Newcastle Inner City Bypass
Rankin Park to Jesmond

**Newcastle Inner City Bypass –
Rankin Park to Jesmond
Submissions and preferred
infrastructure report**

June 2018

Figure 5-1c
The project

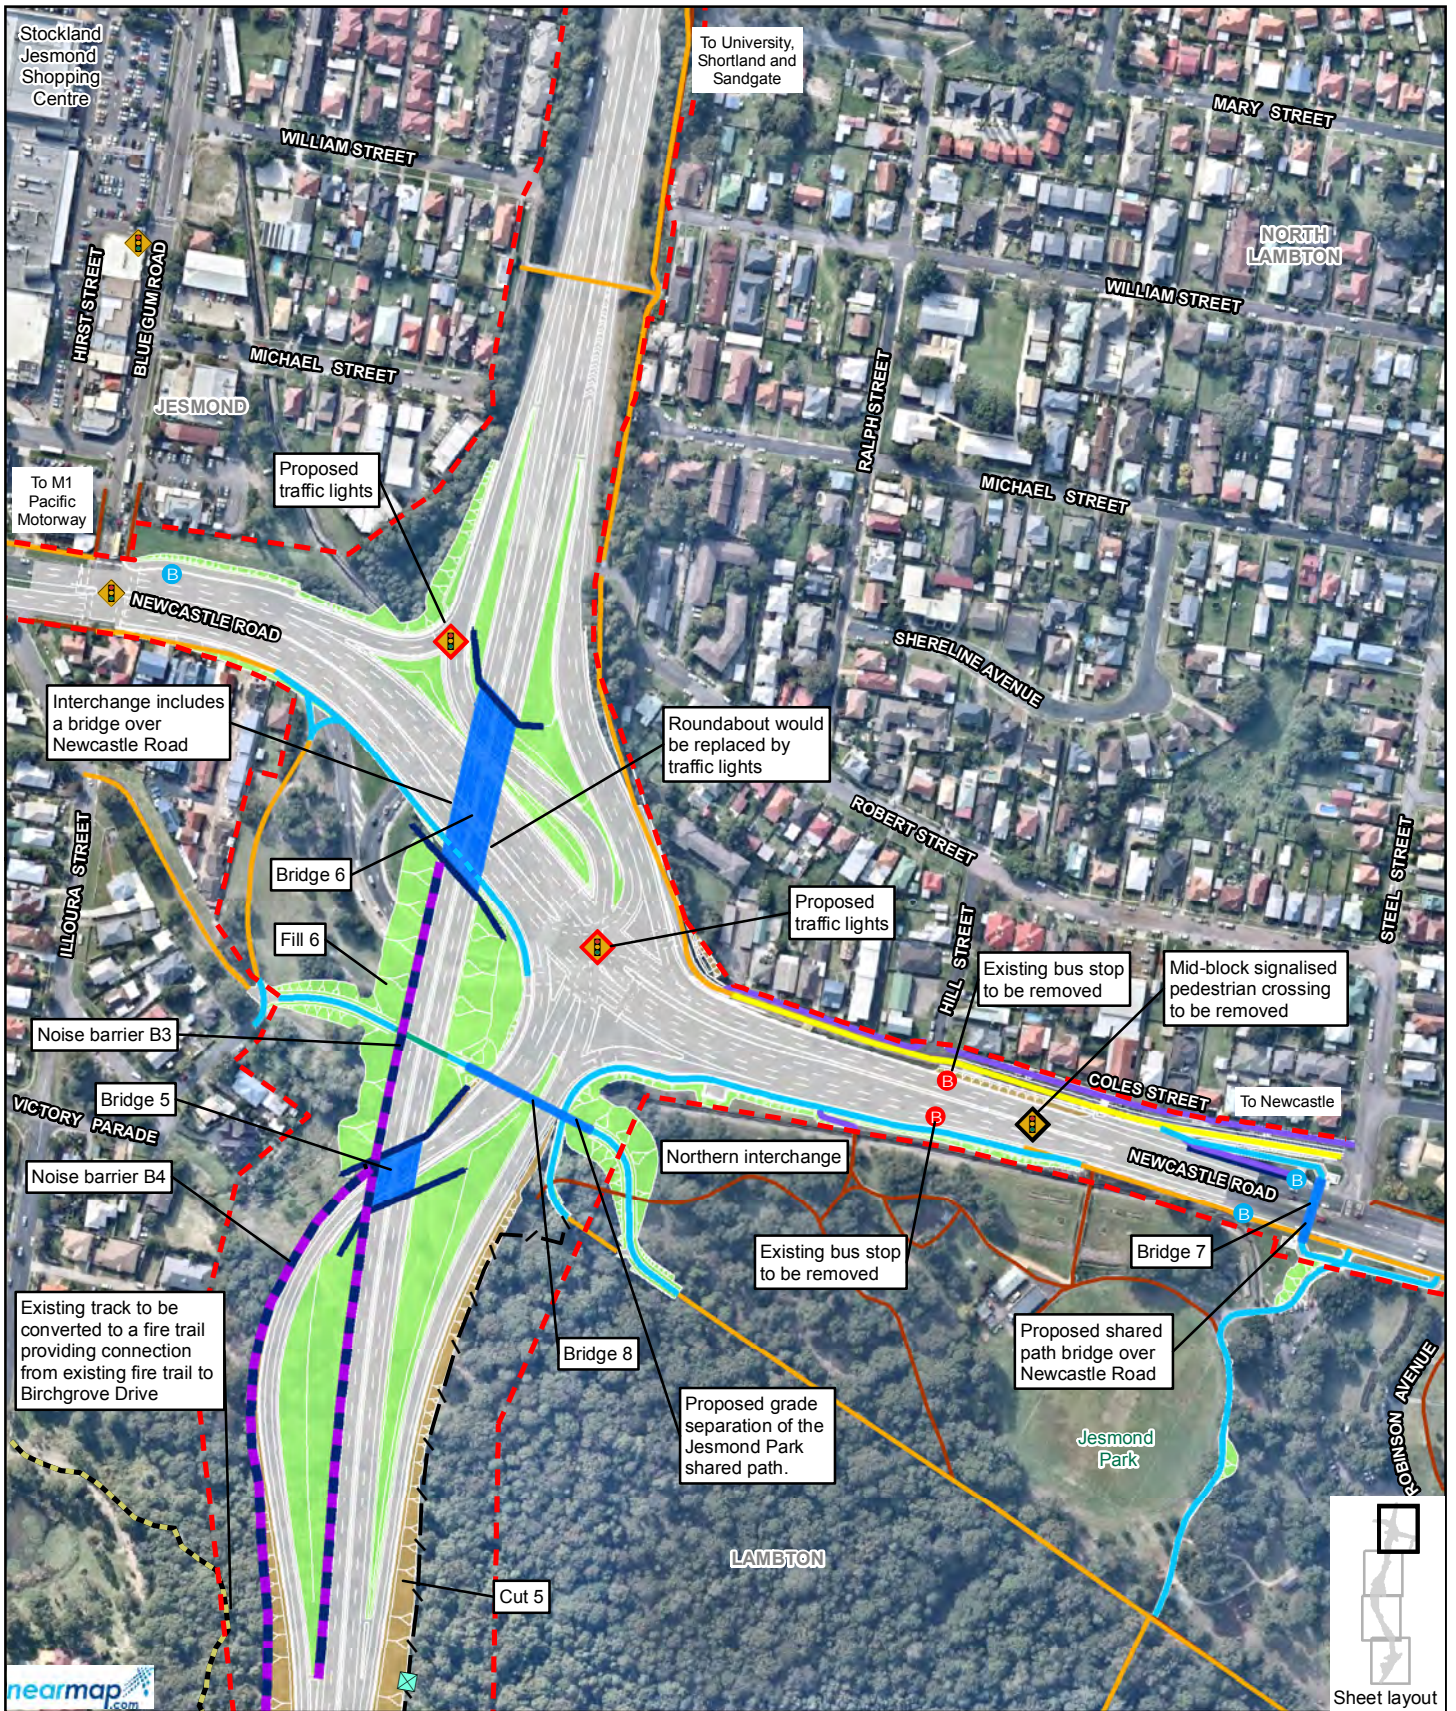
These are described in the following sections and key refinements are shown in Figure 5-1.

To assist with ongoing water quality control during operation of the project it is now proposed to retain and modify eight of the construction sedimentation basins as operational water quality treatment structures, as shown in Figure 5-1. Vegetated swales are also proposed to be constructed along batters as operational water quality treatment structures. Vegetated swales are proposed to be constructed where batter grades are suitable (where batter grades are between one and five per cent). These structures would capture stormwater runoff from all operational areas of the project (excluding existing roads).

Areas of cut and fill are shown in Figure 5-1 and detailed in Table 5-5. In Table 5-5 the change as a result of the design refinements is indicated in brackets. Further description of the proposed earthworks associated with cuts and fills are detailed in Section 5.5.10.

Figure 5-2
 Hospital interchange

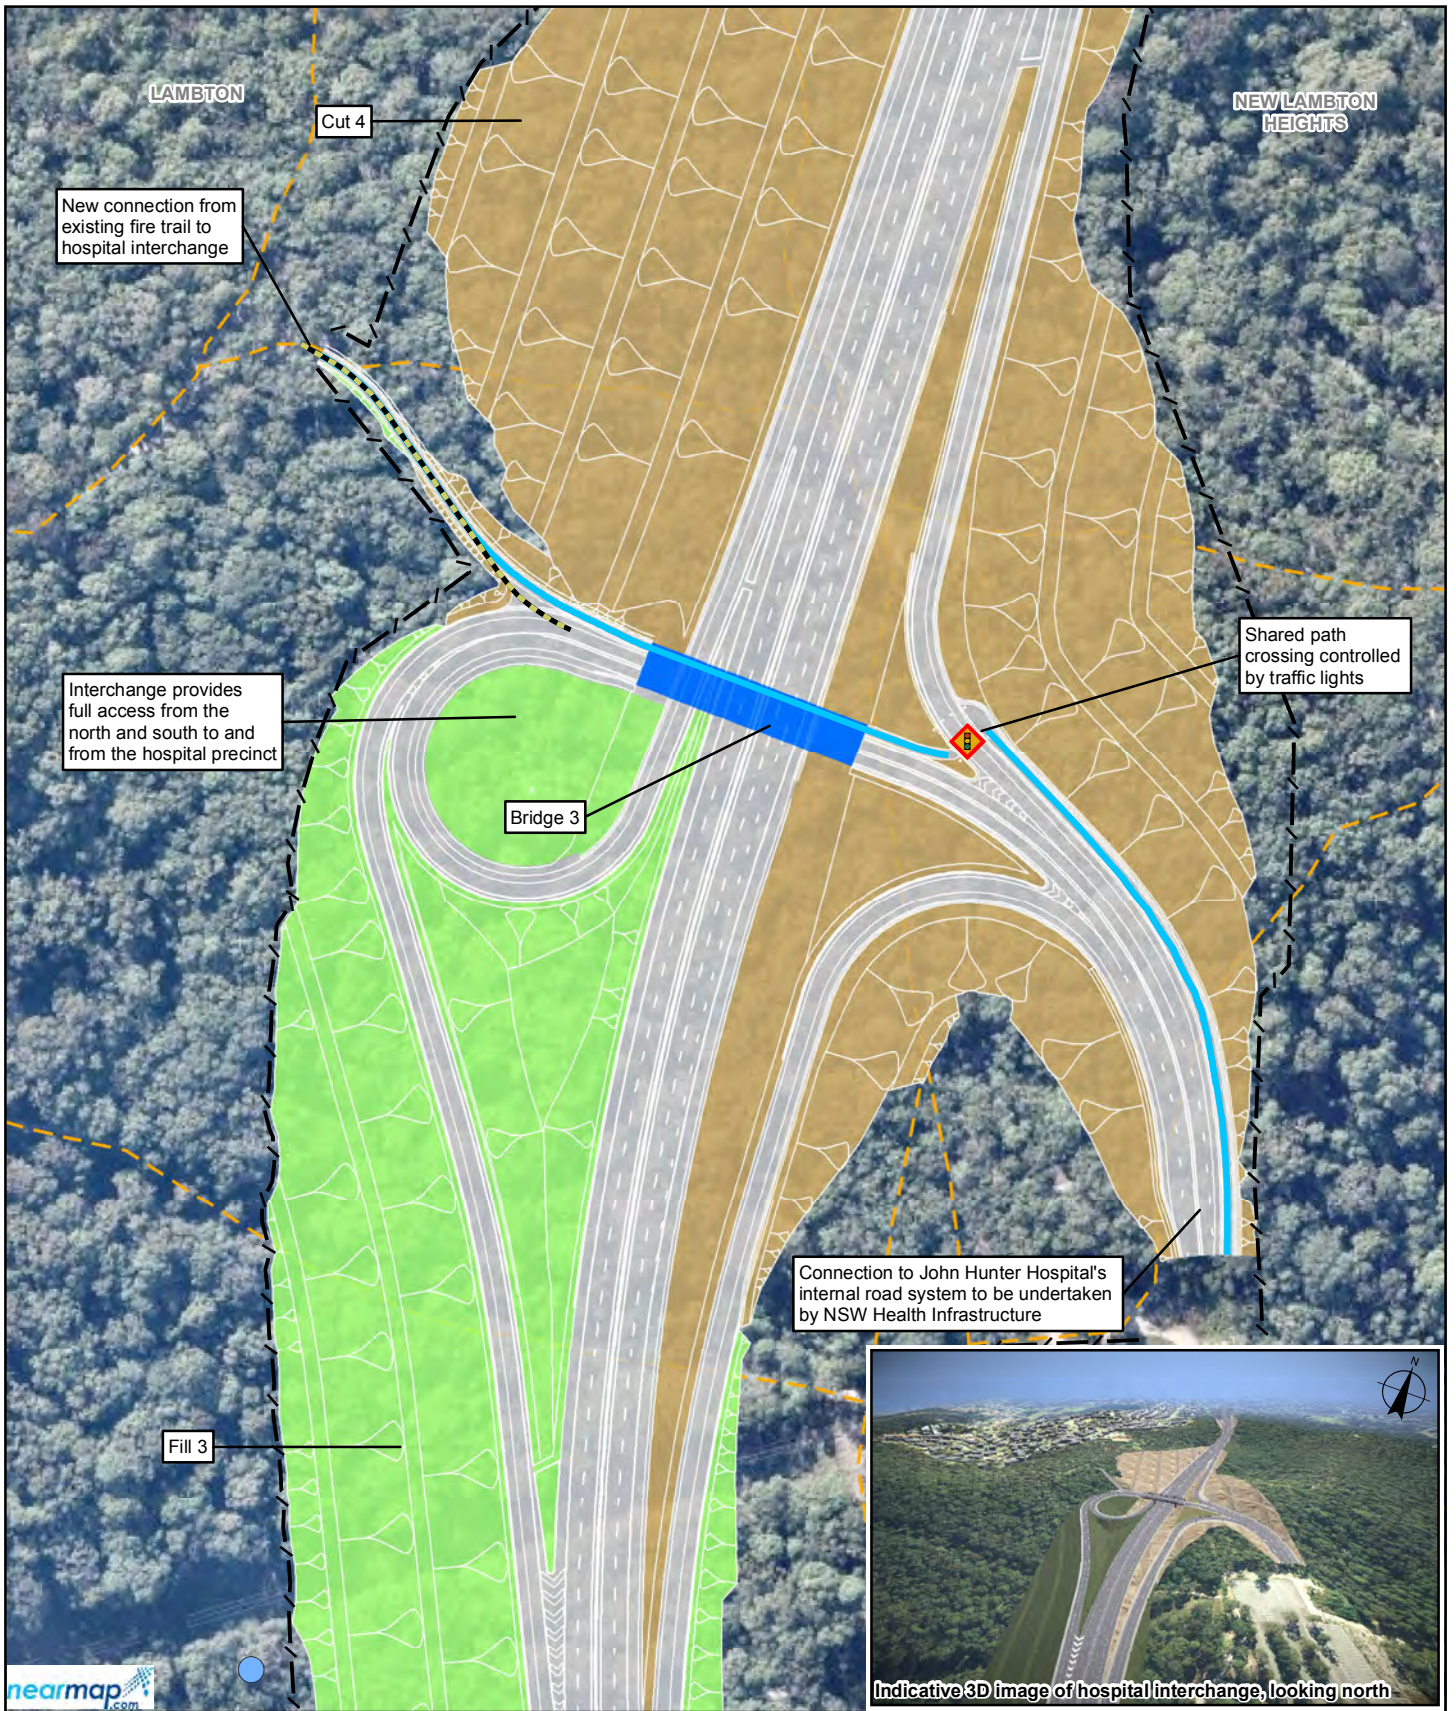
The proposed design refinement to the hospital interchange consists of:

- Access to/from the south which includes a southbound on-ramp to enter the bypass and exit the hospital precinct and a northbound off-ramp to exit the bypass and enter the hospital precinct
- Widening of the bridge (Bridge 3) over the bypass to provide an additional traffic lane, as discussed in Section 5.5.1.

The hospital interchange would now be a full interchange with both north and south-facing ramps as shown in Figure 5-2.

Figure 5-3
Jesmond Park shared path grade separation

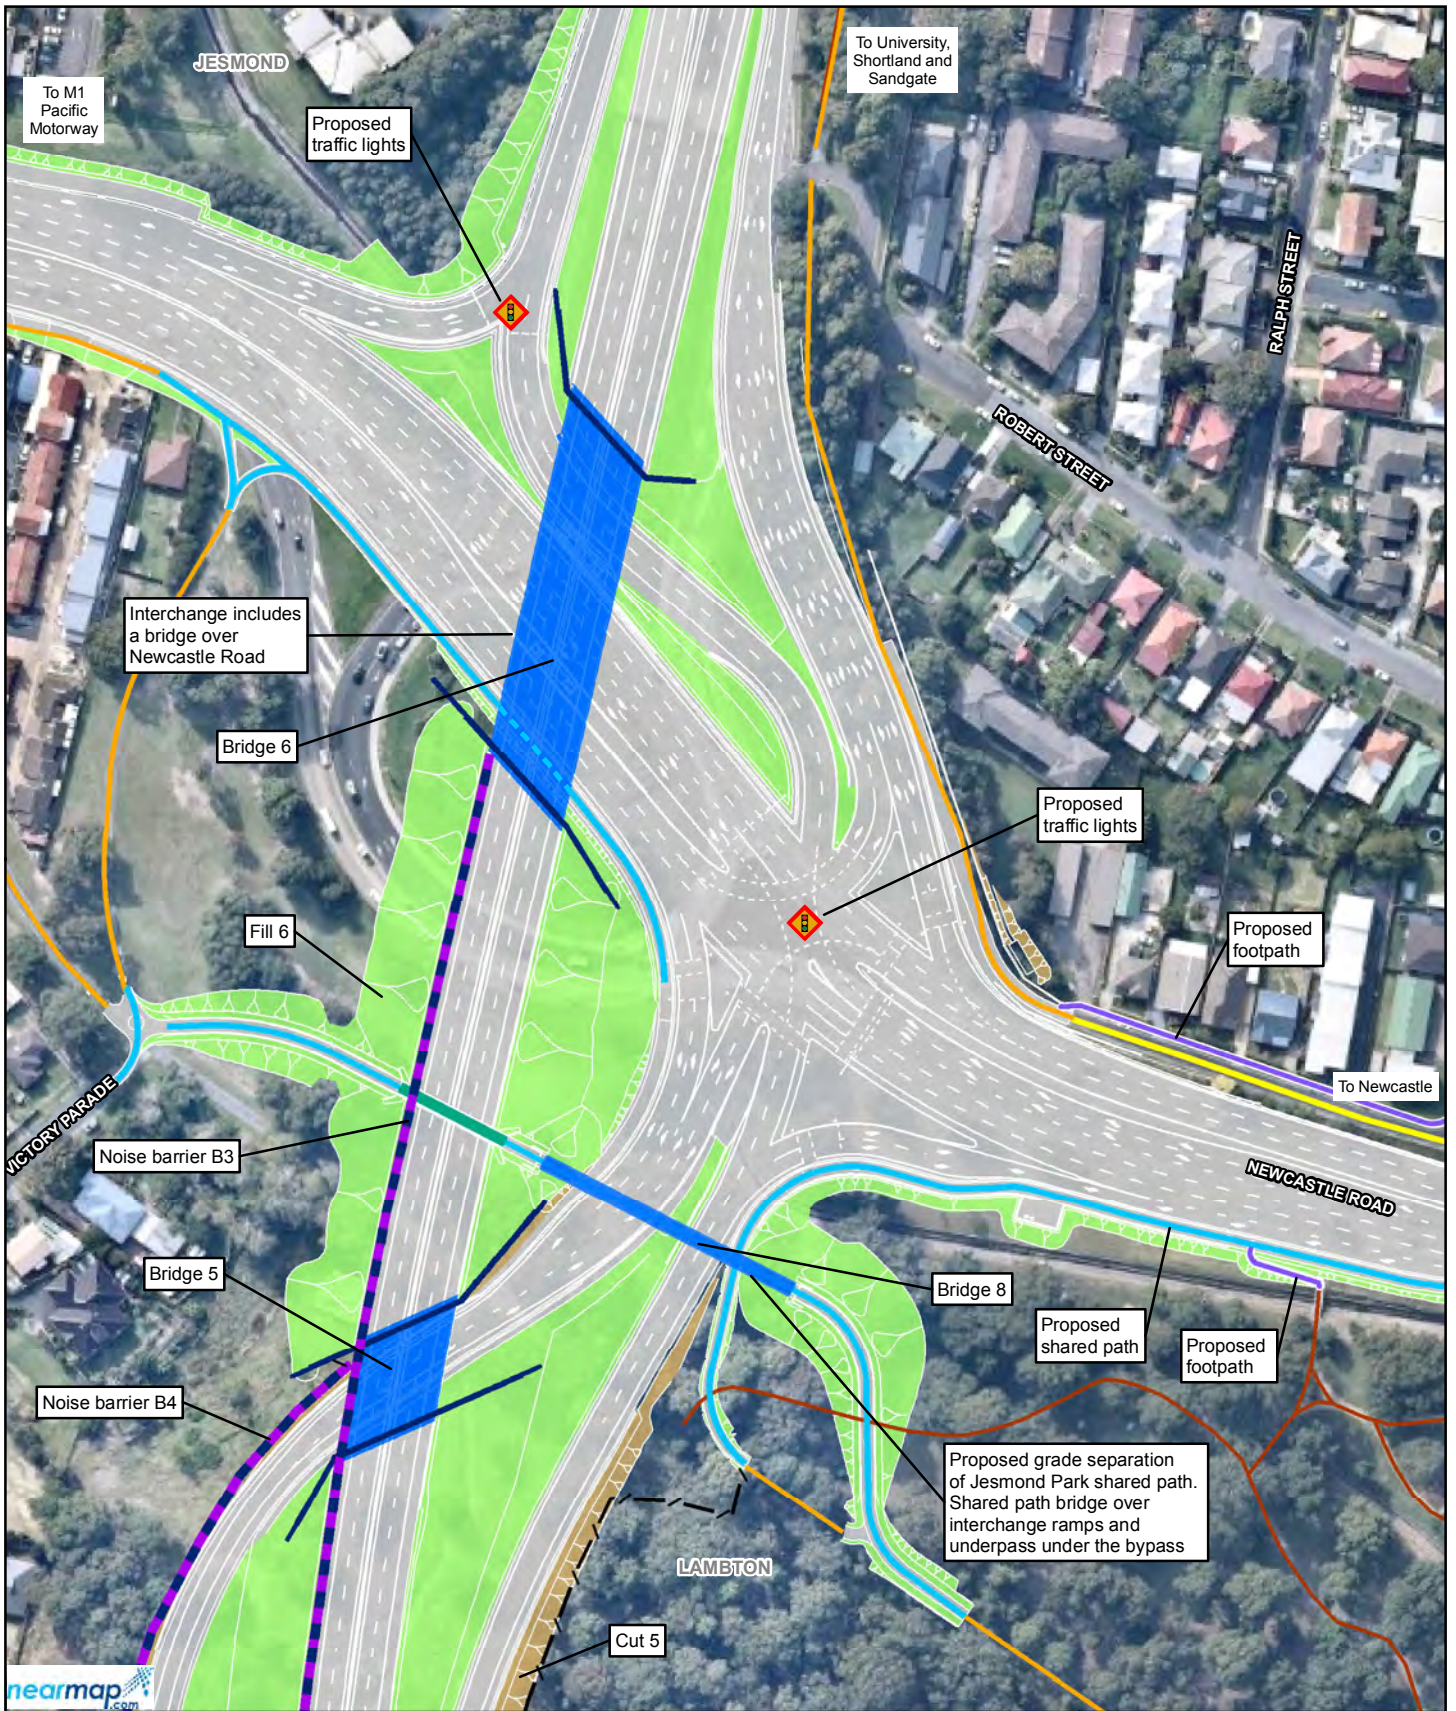
The project would now provide a grade separated shared path consisting of an overpass bridge (Bridge 8) and underpass arrangement, which would connect with existing shared paths as shown in Figure 5-3.

This means pedestrians and cyclists do not need to cross the project via traffic lights for east-west movements. This would provide access to the Newcastle Road and Blue Gum Road intersection via Illoura Street. Refer to Section 5.5.1 for further information regarding the design of the overpass bridge and underpass arrangement.

The three traffic light controlled crossings on the southern side of the northern interchange (as proposed in the EIS design) would be retained in the refined design, to provide for wheelchairs and mobility impaired persons, and as an alternative route for pedestrians and cyclists.

Figure 5-4
Bridge 8

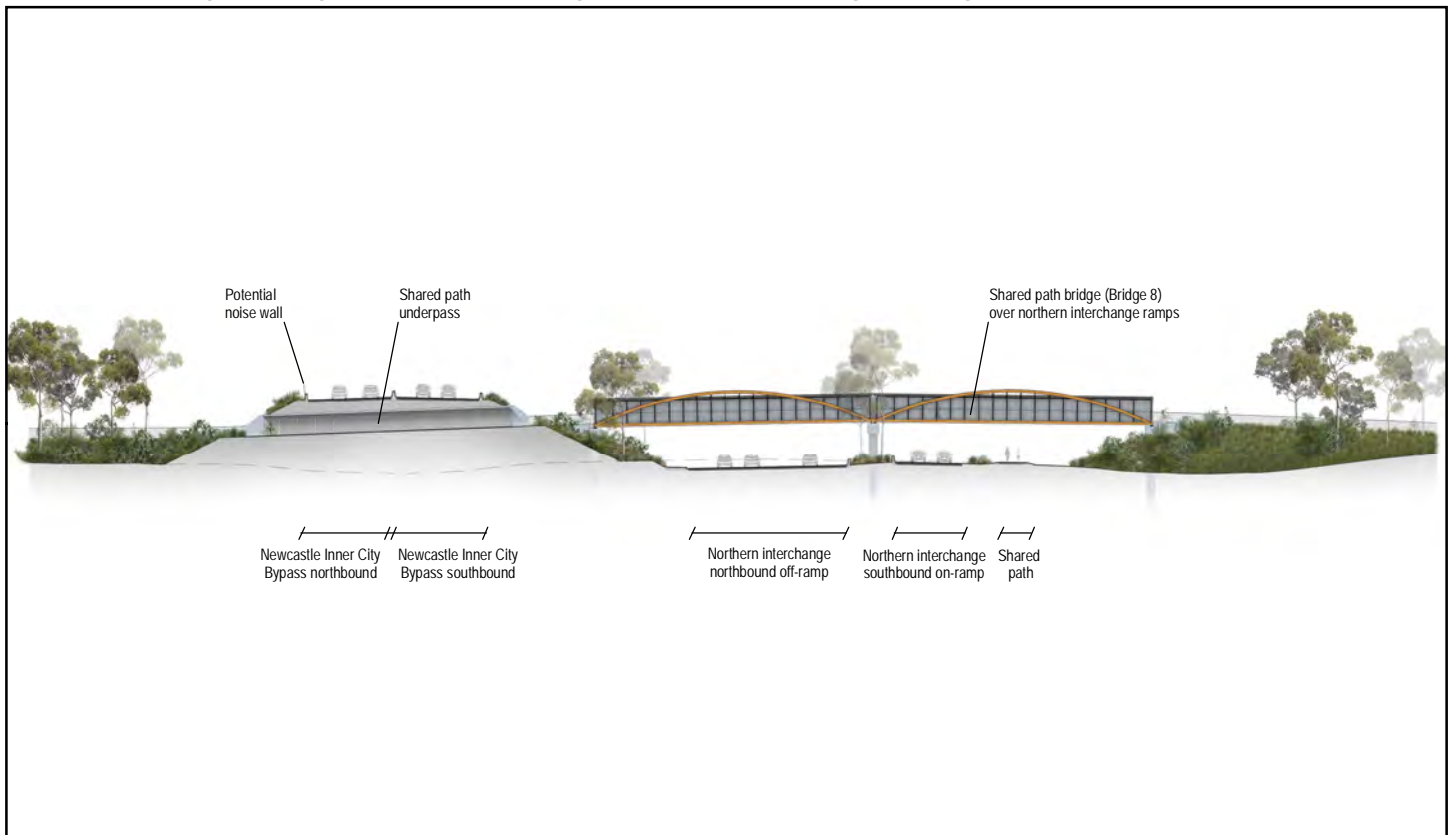
The new Bridge 8 (Figure 5-4) would be a two span steel arch structure and about 77 metres in length. One support pier would be located between the northbound off-ramp and southbound on-ramp.
